Work Order ID 129191

Item ID: D139-816-011 Accept *N900040100* Setup Start *NS1*
 Revision ID: Stop *NS2*
 Item Name: Lightweight Interior Ceiling Panel
 Start Date: 1/30/2015 Start Qty: 1.00 *1* Cust Item ID:
 Required Date: 1/30/2015 Req'd Qty: 1.00 *1* Customer:
 Reference:

The purpose of this Dart Service Instruction (DSI) is to provide an alternate method of installing the D139-816-011 Interior Ceiling Panel Kit for customers with newer 300 series aircraft models with split center ceiling panels.

The purpose of this Dart Service Instruction (DSI) is to provide instructions to install the D5078-1 Bracket to support the Overhead Connector for D139-811-011 Interior Ceiling Panel Kit.

Figure 1. - LH Side Overhead Panel

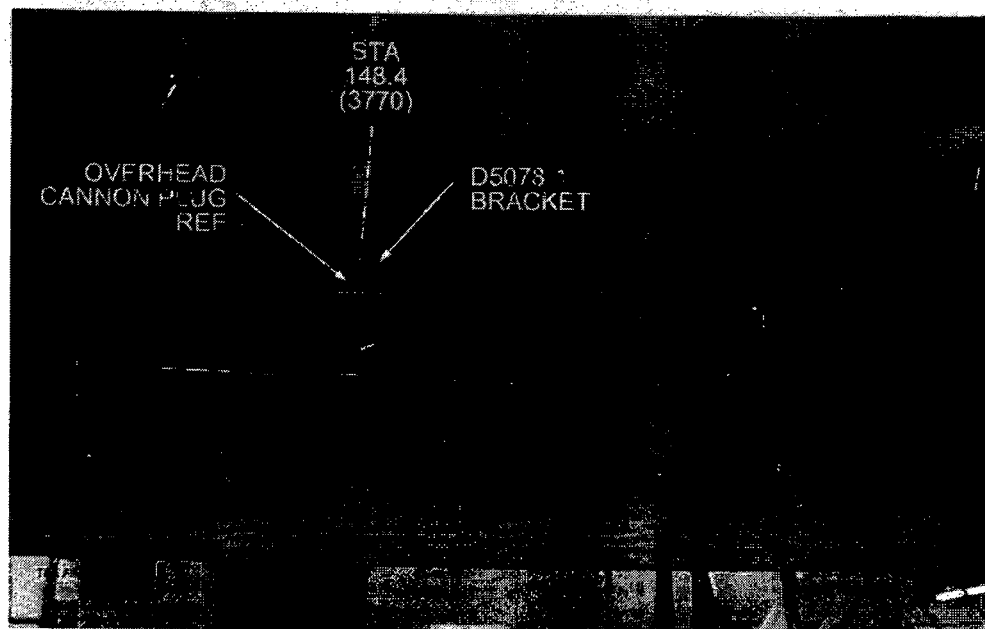
This procedure is added after step 3.1.39 of IIN-D139-816 Rev. D.

- 2.1 Position the D5078-1 Bracket on the LH side of the cabin overhead by temporarily removing 2x MS27039-1 screws as shown in Figure 1. Transfer 2x $\varnothing 0.204$ " (#6 drill) holes from airframe to the D5078-1 Bracket. Deburr and touch-up holes with MIL-P-85582 or MIL-P-23377 primer.
- 2.2 Install D5078-1 Bracket using existing 2x MS27039-1 screws and washers as shown in Figure 1.
- 2.3 Install overhead cannon plug in the D5078-1 Bracket using existing NAS1801/1802 screws and existing AS85049/95-20A-A Perimeter Mounting Flange as shown in Figure 2.
- 2.4 Reconnect wire harness to overhead cannon plug as shown in Figure 2.

The D5078-1 bracket has been added to D139-816-011 Kits at CHG 005 and later. Customers who wish to obtain the D5078-1 Bracket for a kit that has already been installed can procure the DSI 9691-011 kit from Dart as outlined below.
